CHANGE ORDER

No. 3

DATE OF ISSUANCE April 14, 2016 **EFFECTIVE DATE** April 14, 2016
OWNER Lexington-Fayette Urban County Government
CONTRACTOR Judy Construction Company
Contract: Wolf Run Wet Weather Storage Facility
Project: Wolf Run Wet Weather Storage Facility
OWNER'S Contract No. WR-8; Bid No. 21-2015 **ENGINEER'S Contract No.** 200-11681-14002
ENGINEER Tetra Tech, Inc.

**Change Order No. 3
Lexington-Fayette Urban County Government
Wolf Run Wet Weather Storage Facility**

CO-2

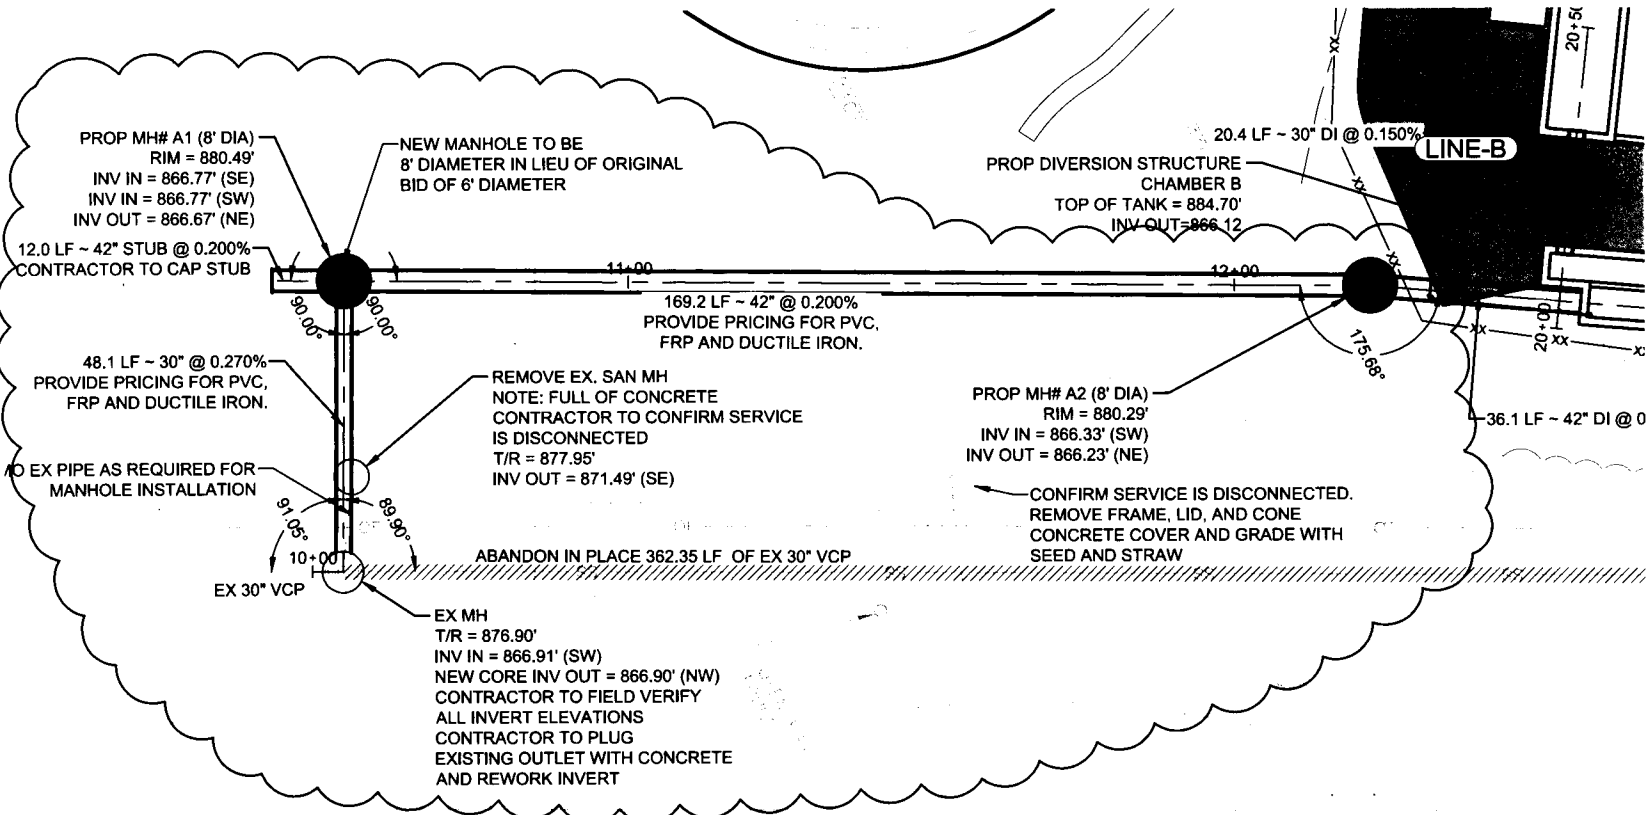
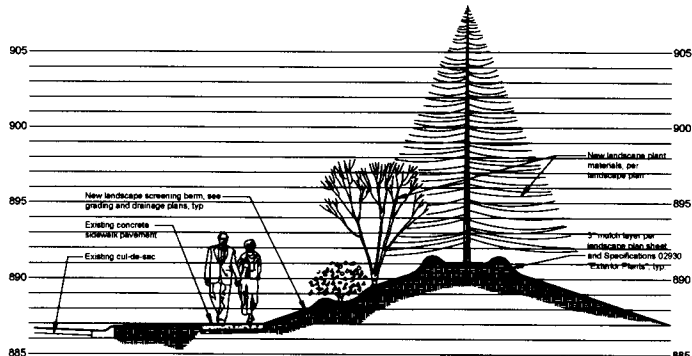
Item 1-3

- C. Measurement and payment for this item shall be on a lump sum basis for work completed, tested and operational piping.
- D. This item includes all materials, equipment, labor, hauling, testing and incidentals required for the Contractor to complete the work shown on exhibit CO-2. Work under this item includes the installation of 170 linear feet of 42-inch FRP gravity pipe, the installation of 49 linear feet of 30-inch FRP gravity pipe, the coring of the existing manhole, and the removal of an out of service manhole. Incidental to this item is bypass pumping, and required tree removal, the removal of any required utilities.

We have prepared the following proposal for the additional 42" gravity sewer line per your drawing CO-2. Our price includes provisions to remove the existing power pole, cable and phone lines, as well as a tree by the existing manhole. The base price includes using HOBAS piping with alternate pricing for Ductile Iron and PVC.

We are concerned the existing 4' diameter manhole that we are tying the new 30" line into may need to be replaced. We have not included a new 4' diameter manhole in our price or any work associated with the existing gravity sewer line. If requested, we can provide a proposal to replace the existing manhole after it is exposed and inspected.

Judy has provided a lump sum cost of **\$148,328.00** for the additional 42-inch and 30-inch piping requested by LFUCG. Tetra Tech requested that Judy provide a price for FRP piping, PVC, and Ductile Iron. The price of \$148,328.00 is for the installation of FRP. PVC and ductile iron increase the lump sum cost \$17,819.00 and \$32,035.00 respectively. The additional piping is currently included in a future Remedial Measures Program project. LFUCG requested Judy to provide a price for the additional piping at this time to avoid disturbing the Wolf Run Wet Weather Storage Facility site with future projects. Tetra Tech recommends LFUCG approve this portion of the work, at the price given for FRP to avoid disturbing a recently finished project with future construction. The material cost for the additional piping, manholes, erosion control, pipe bedding, etc. is \$67,460.00. This material cost includes a credit to LFUCG of \$12,637.00 for the 8 foot diameter manhole and the 50 linear feet of 42-inch ductile iron pipe included in the original contract documents. The lump sum price submitted by Judy also includes \$38,694.00 in labor cost, \$19,924.00 in subcontracting cost and \$22,250.00 in overhead and profit. The subcontract costs include the cost of bypass pumping, temporary fencing, seeding and manhole coring. The overhead and profit is at the Contract Document approved fifteen percent (15%).

L-501

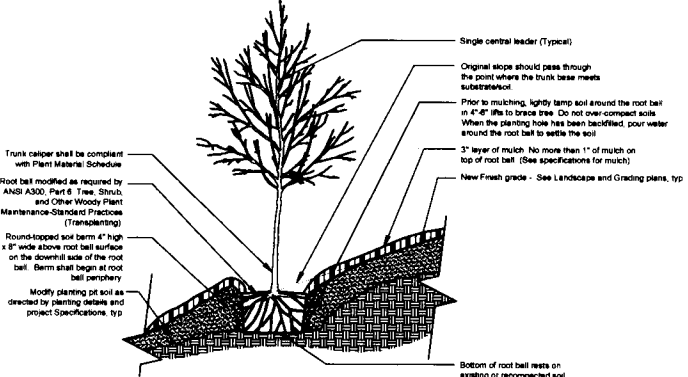
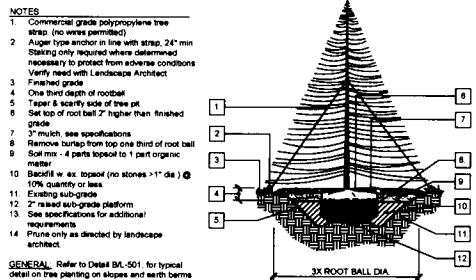
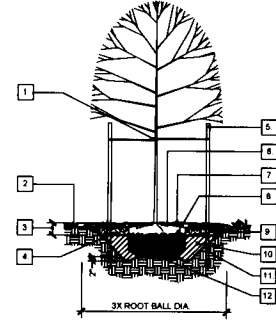
Item 1-4

- A. Measurement and payment shall be on a lump sum basis for the architectural improvements listed below.
- B. This item includes all materials, equipment, labor, hauling, and incidentals required for the Contractor to complete the architectural improvements shown on Sheets L-201, L-501 and L-502, attached. Work under this item includes replacing a portion of the original contract chain link fence with approximately 180 linear feet of a faux wrought iron fence, installing stone columns at the entrance and changes to the landscaping plan.

We have prepared the following proposal for the architectural improvements to the landscaping and fence per your drawings L201, L501 and L502.

Valley neighborhood. Council Member Henson requested changes including modifications to the proposed landscaping, installation of a faux wrought iron fence in lieu of the proposed chain link fence, only for the visible portion of the proposed fence, and installing stone columns and an architectural gate in lieu of the proposed gate. Per Judy, the additional faux wrought iron fence has a lump sum cost of \$29,062.00, the modified landscaping will cost \$4,120.00 and the Masonry for the stone columns will cost approximately \$4,998. Judy provided a credit of \$8,363.00 for the material cost of the chain link fence included in the original contract documents, which is approximately \$61.50 per linear foot of fence base on 136 linear feet of fence. The material cost for the new faux wrought iron fence is \$37,425.00, approximately \$275.20 per linear foot. Tetra Tech recommends LFUCG approve this portion of the change order, as it was requested by Council Member Henson to approve the aesthetics of the tank for the surrounding neighborhood.

L-502

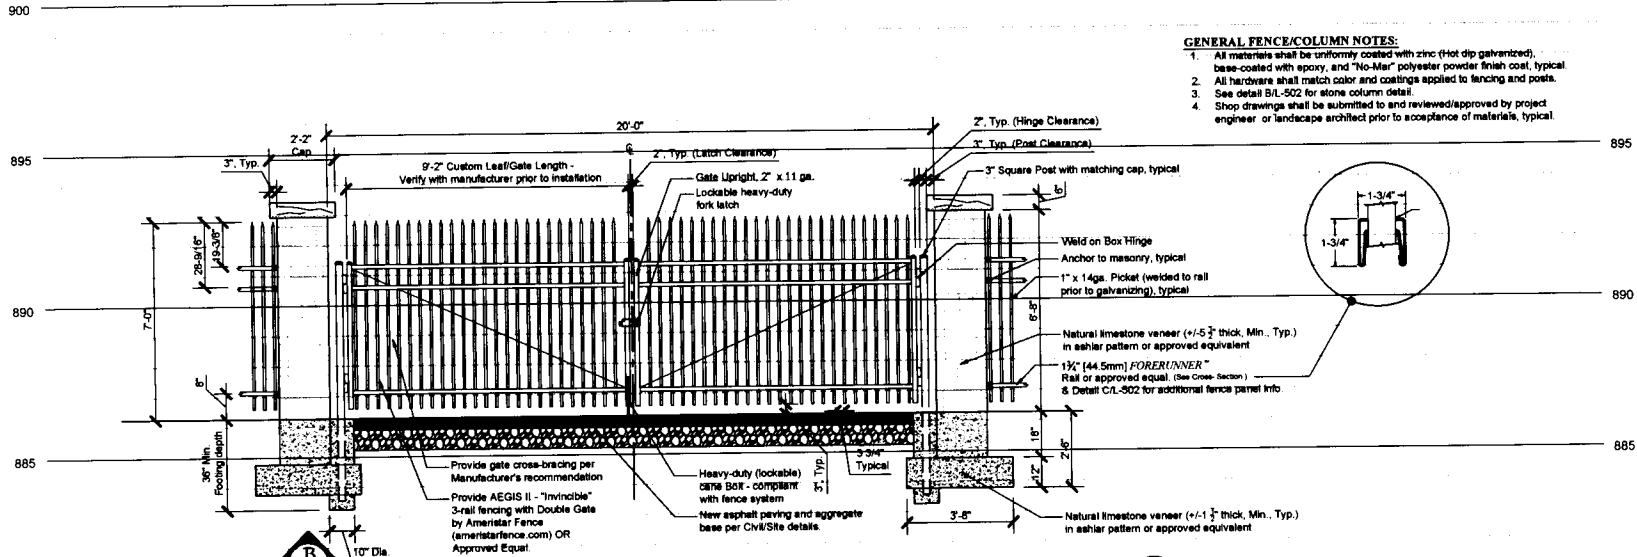
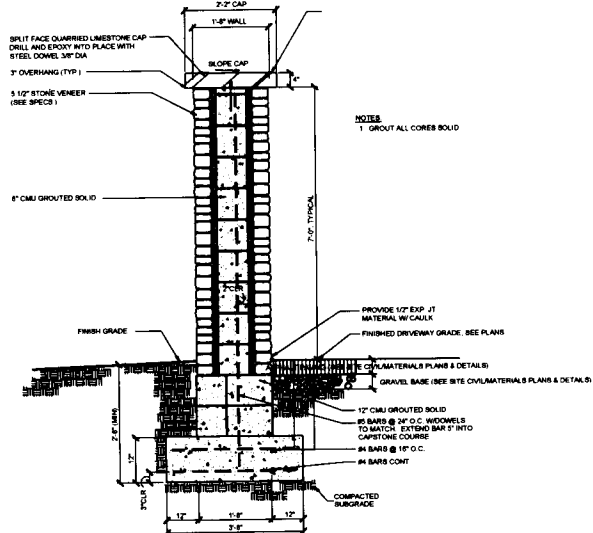
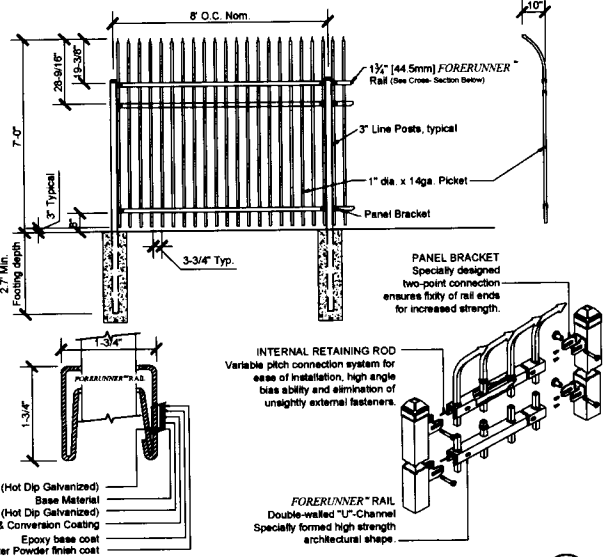
He didn't give a per foot price because the fence is panelized and has several components. He didn't want to price it by the foot because it wouldn't be accurate. There is a total of 136LF
